## West Valley Demonstration Project

NRC REQUEST FOR INFORMATION ON  
THE WVDP PHASE 1 DECOMMISSIONING PLAN

# PROPOSED DOE RESPONSES

*June 15, 2009*

Process Building  
Foundation Piling  
(Typical)

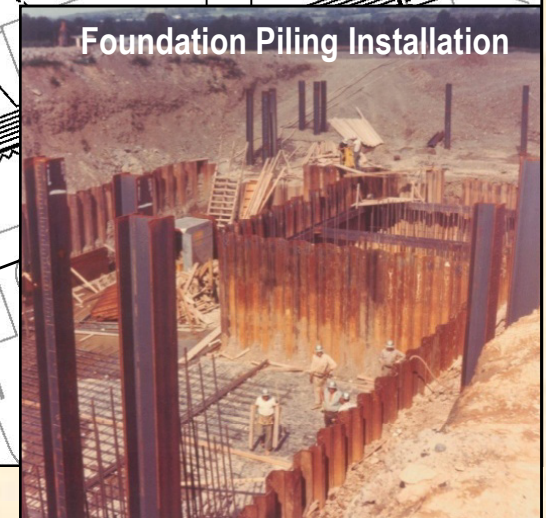
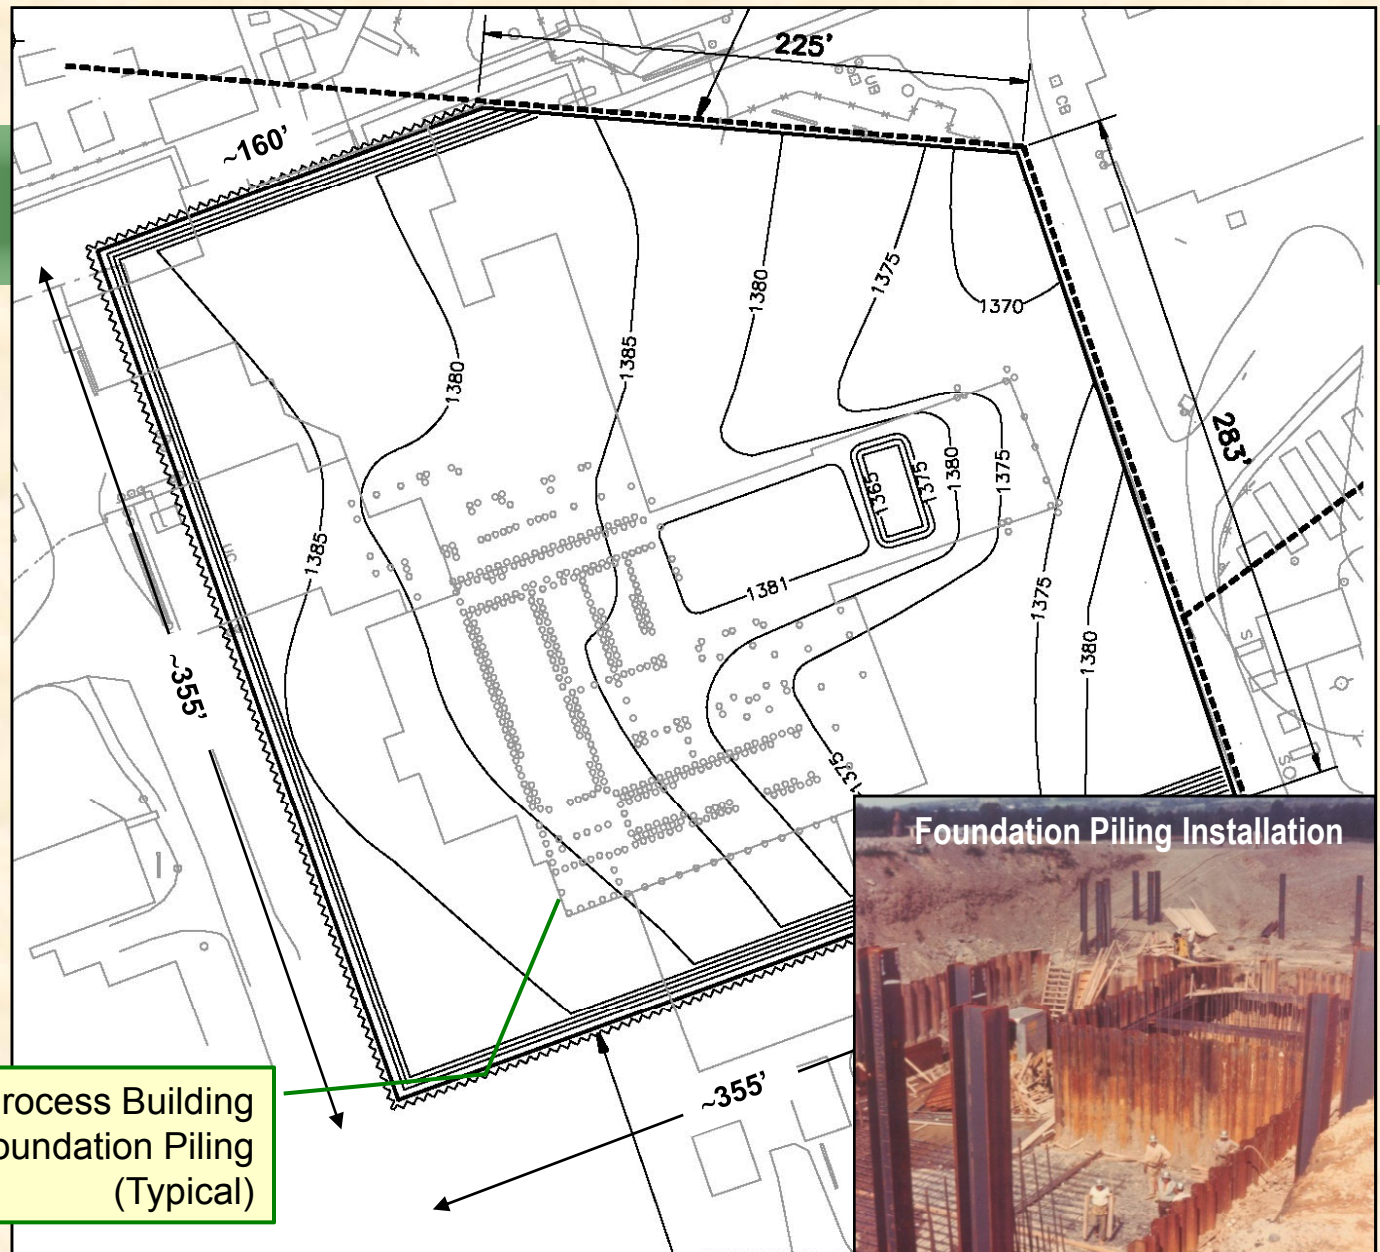
**NRC path forward:** Provide a description of the areal and vertical extent of sampling for contamination that has been completed associated with the H-piles and other discrete engineered features relative to past major spills, leaks, or known large sources of activity.

- ❑ Future sampling along H piles specified in CSAP will be important to understanding conditions below the excavation bottom
- ❑ Sampling of near-surface discrete engineered features (wells, underground tanks and lines) provides waste management information; these features do not provide a potential pathway to deeper groundwater
  - Groundwater wells do not extend into ULT
  - Any contamination related to wastewater tanks and underground lines, which are relatively near the surface, is expected to be in soil to be excavated and disposed of offsite

- ❑ 476 pilings
- ❑ Systematic surveys planned during excavation when all pilings become accessible
- ❑ This will be covered in CSAP

**Proposed DOE approach:** Perform additional characterization specified in CSAP

# 9C4 (35), (3 of 4)

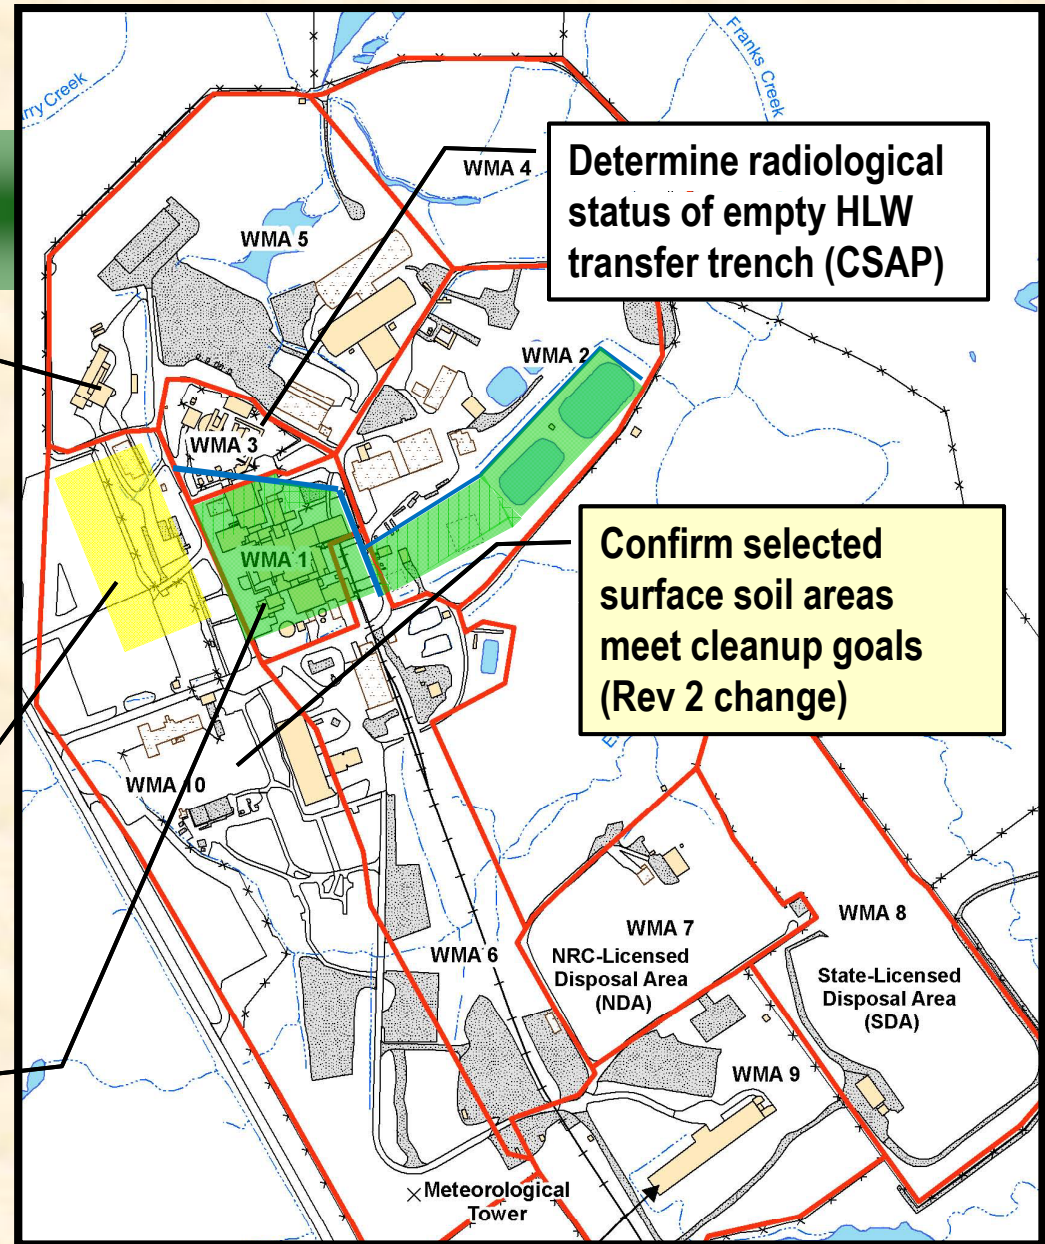
- **NRC path forward**: Given the characterization data collected to date and the development of the Characterization Plan, In-process/Remediation Action Support Survey information demonstration, and determination of how background concentrations will be applied, provide the details for the Final Status Survey Design for Phase 1 areas. NUREG-1757, Vol.2, Section 4.4 and Appendix E (NRC, 2006) and NUREG-1575 (NRC, 2000) provide additional guidance for Final Status Survey Design.

Determine radiological status of soil in footprints of removed infrastructure (CSAP)

**Proposed DOE approach**: Describe the conceptual framework for the FSSP design in detail in the comment response, and later provide the FSSP to NRC for information as has been planned. (The conceptual framework could be included as a new appendix in the DP, if that is considered to be necessary.)

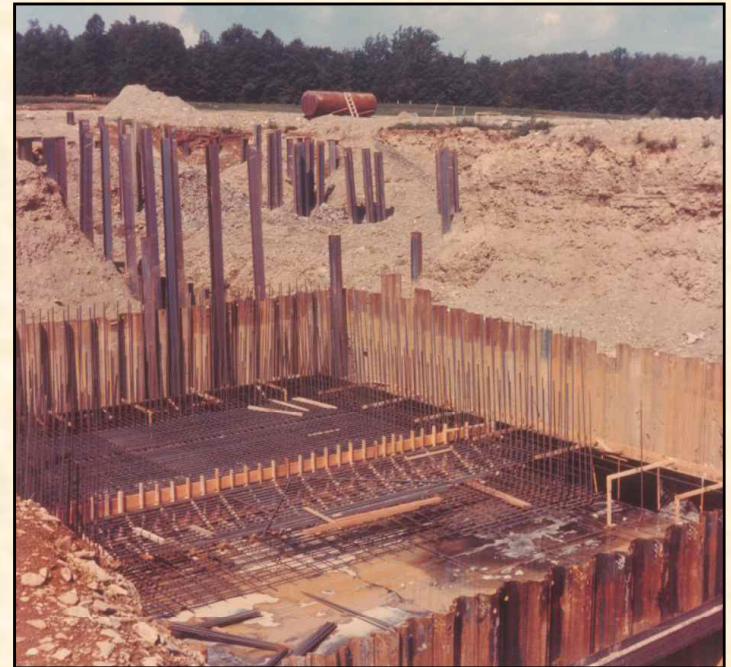
**NRC path forward:** Provide a more detailed discussion of the impact of the excavations on water flow patterns and summarize the experience with interlocking sheet piling.

- ❑ Bechtel used temporary interlocking sheet piling to support the excavation and construction of subsurface facilities including tanks 8D-1 and 8D-2 and the fuel storage and cask unloading pools
  - Historical photos show the pilings to be effective in controlling groundwater intrusion

**Proposed DOE approach:** Provide additional discussion as requested
